# RENESAS TECHNICAL UPDATE

Product Category	MPU/MCU		Document No.	TN-SY*-A0045A/E	Rev.	1.00
Title	Errata for User's Manual regarding the IIC		Information Category	Technical Notification		
Applicable Product	Renesas Synergy™ S128 MCU Group	Lot No.	Reference Document	S128 Microcontroller Group User's Manual Rev.1.10		
		All

The specified Renesas Synergy S128 User's Manual has incorrect statements about the IIC.

## Page 765 of 1232

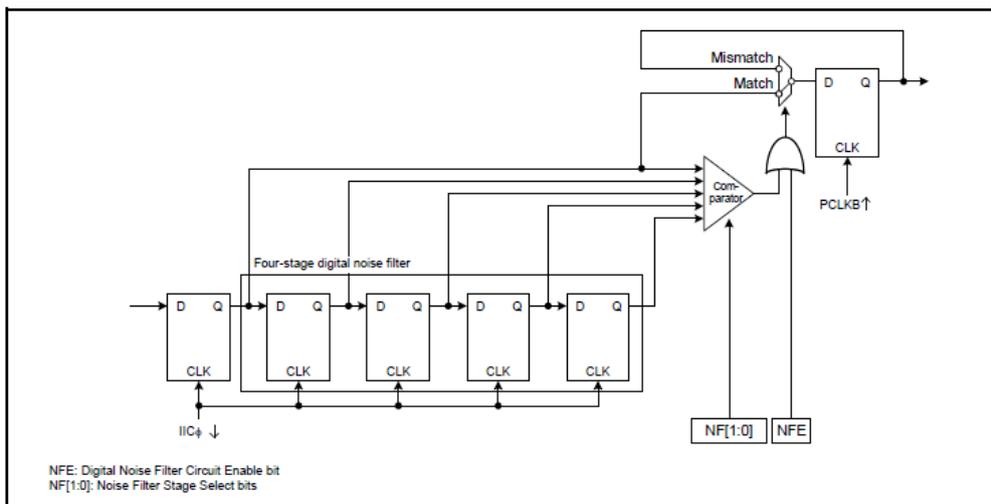
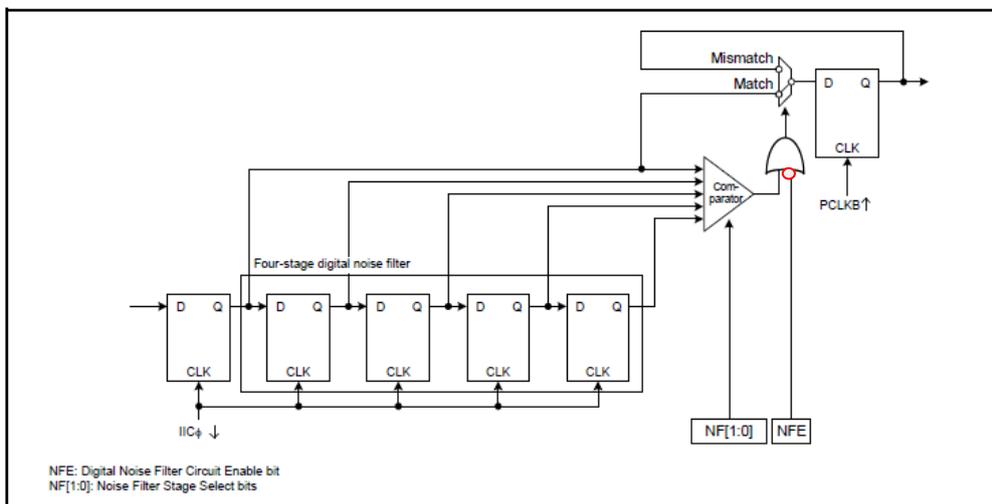
### Incorrect

The IIC can also set the AL flag to indicate the detection of arbitration loss during NACK transmission in master mode or during data transmission in slave mode.

Incorrect Figure

### Correct

The IIC can also set the AL flag to indicate the detection of arbitration loss during NACK transmission ~~in master mode~~ or during data transmission ~~in slave mode~~.

Correct Figure

Incorrect Figure

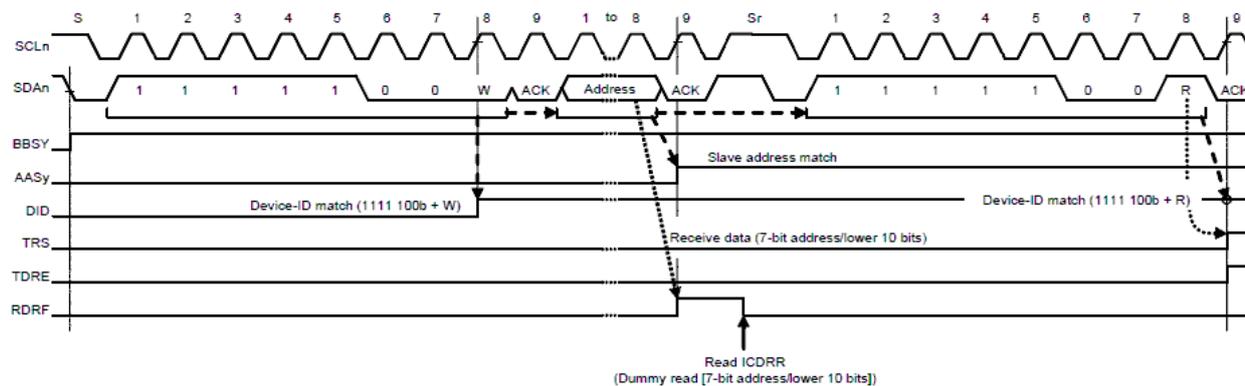
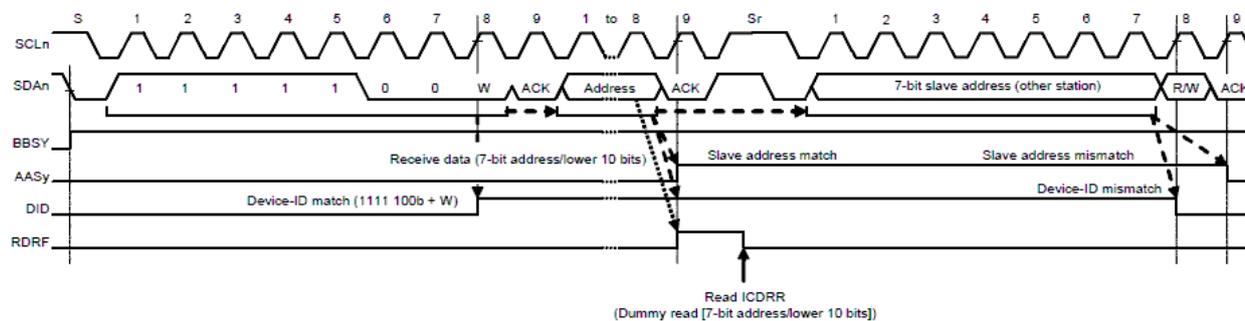
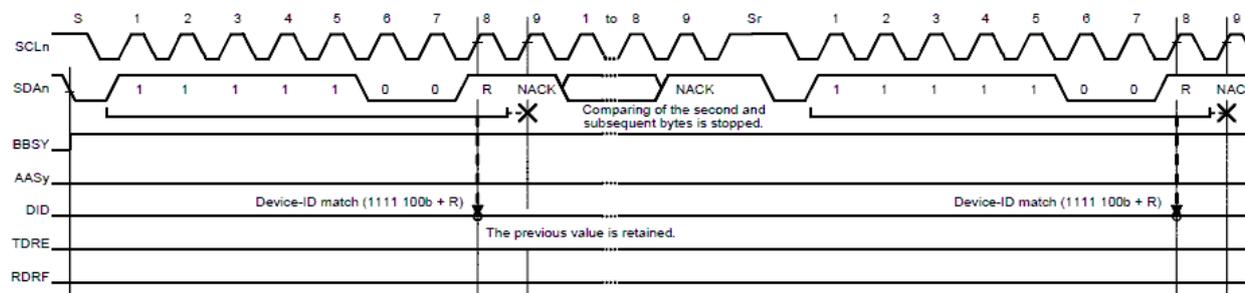
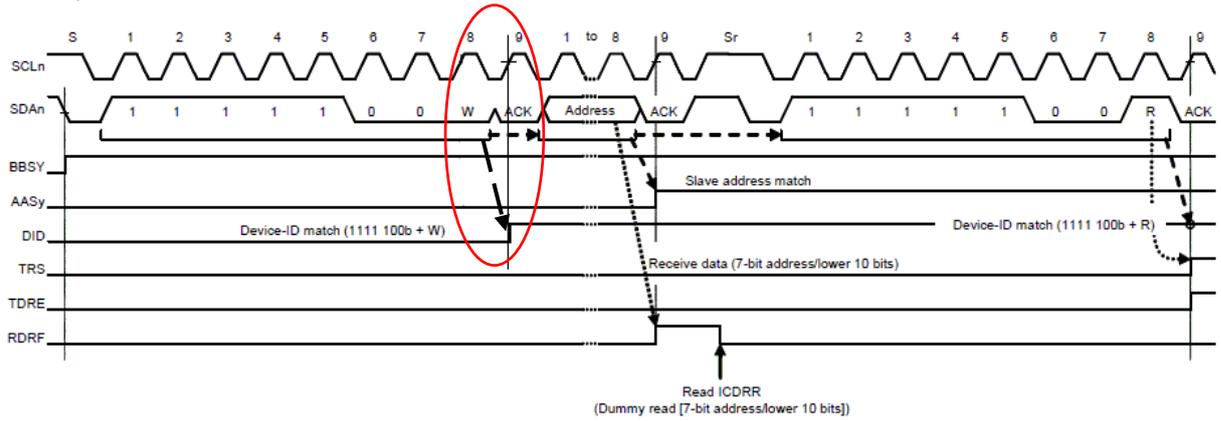
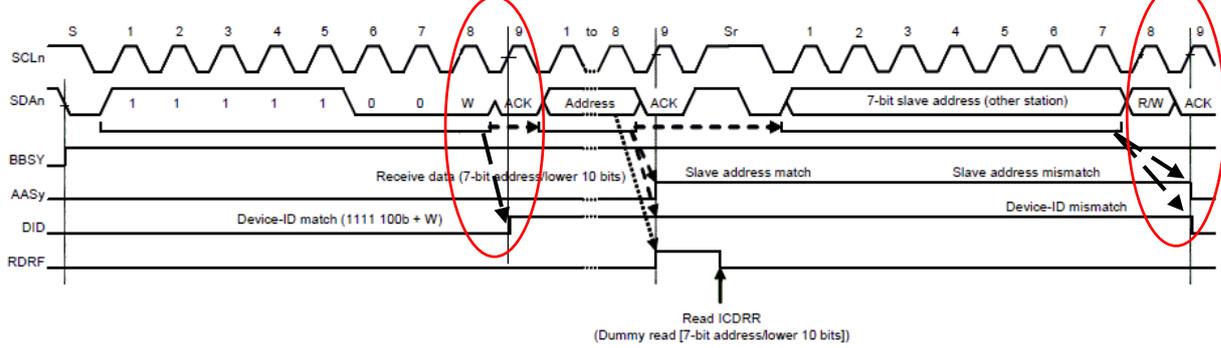
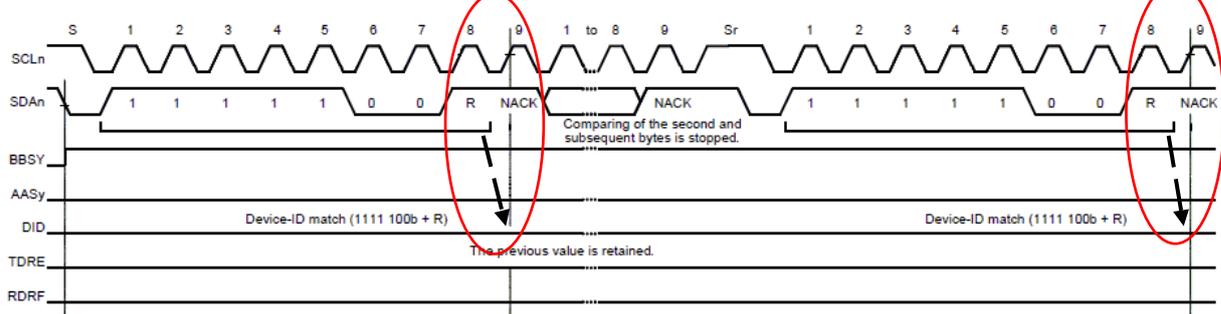
Incorrect

The IIC module provides detection of device-ID address in compliance with the I2C bus specification (Rev. 03). When the IIC receives 1111 100b as the first byte after a start or restart condition was issued with the DIDE bit in IC SER set to 1, it recognizes the address as a device ID, sets the DID flag in ICSR1 to 1 on the rising edge of the eighth SCL clock cycle when the subsequent R/W# bit is 0, then compares the second and subsequent bytes with its own slave address.

Correct

The IIC module provides detection of device-ID address in compliance with the I2C bus specification (Rev. 03). When the IIC receives 1111 100b as the first byte after a start or restart condition was issued with the DIDE bit in IC SER set to 1, it recognizes the address as a device ID, sets the DID flag in ICSR1 to 1 on the rising edge of the **9th** SCL clock cycle when the subsequent R/W# bit is 0, then compares the second and subsequent bytes with its own slave address.

Correct Figure

Page 807 of 1232

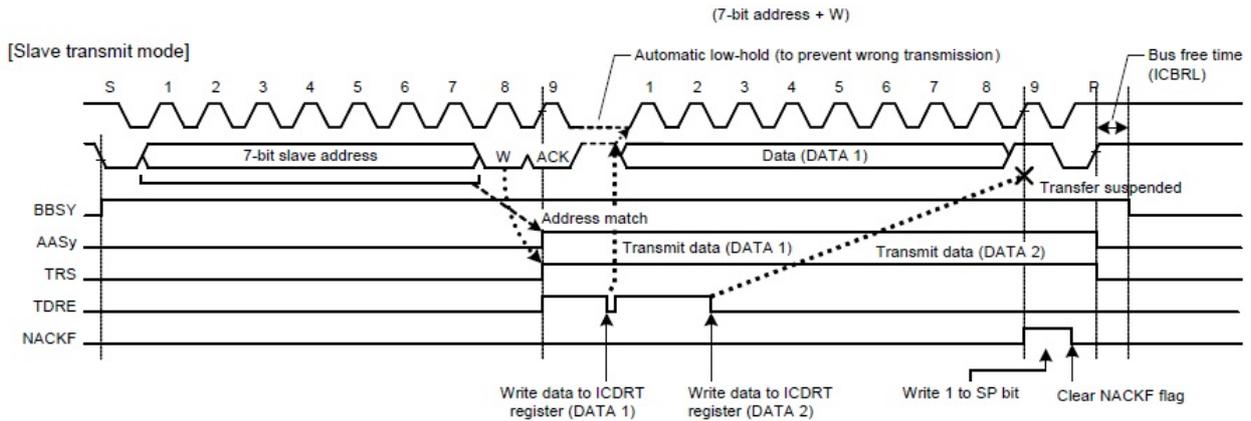
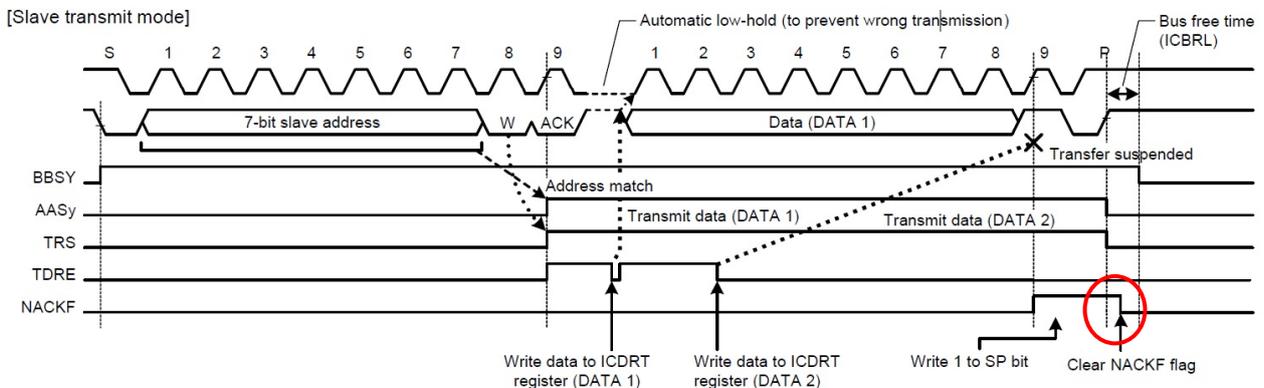
Incorrect Figure

Correct Figure

Page 816 of 1232

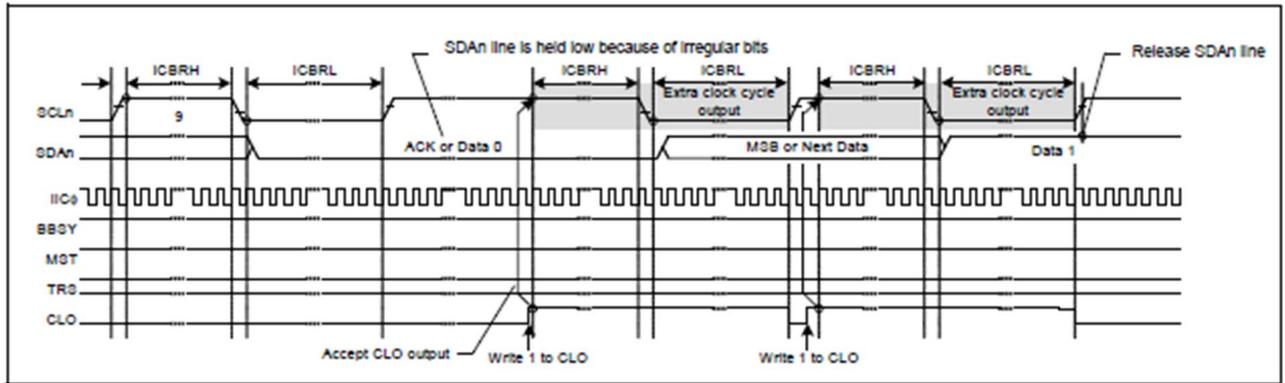
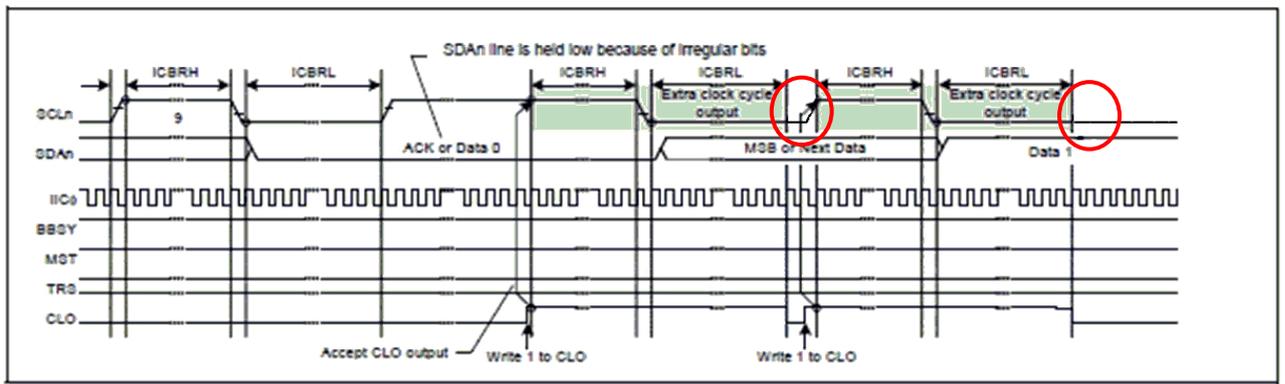
Incorrect

Use this function with the MALE bit in ICFER set to 0 (master arbitration-lost detection disabled). If the MALE bit is set to 1 (enabled), arbitration is lost when the value of the SDAO bit in ICCR1 does not match the state of the SDAn line.

Incorrect Figure

Correct

Use this function with the MALE bit in ICFER set to 0 (master arbitration-lost detection disabled). If the MALE bit is set to 1 (enabled), arbitration is lost when the value of the SDAO bit in ICCR1 does not match the state of the SDAn line.

Correct Figure
